Subject: Amended MHI's Response to US-APWR DCD RAI No.289

# Amended Response to Request for Additional Information No.289 Revision 1

NO. 289-2217 REVISION 1

#### **QUESTION NO.: 05.02.03-12**

Figure 1 SCC resistance of stainless steel against dissolved oxygen

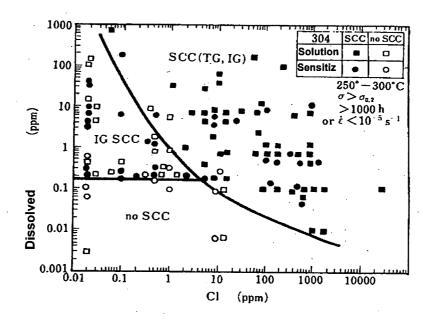
In addition, MHI's SS will also meet URD requirements, because MHI's SS is categorized as "(C) proven material" of table 1, URS 5.3.1.8 line. Figure 1 is demonstration data of the standard grades of SS that shows high IGSCC resistance. The figure 1 shows the relationship between SCC potential and chemical condition of dissolved oxygen and chloride ion (\*1). It is confirmed that the chemical conditions of the US-APWR primary water is in the no SCC area below the curve. This means that the standard grades of SS will not occur IGSCC in PWR environment even if these materials are sensitized. Furthermore, MHI's SS has been applied for pressure boundary components, piping and reactor internal structures in the existing Japanese domestic PWR plants. This service experience which have occurred no IGSCC can support the demonstration data in figure 1.
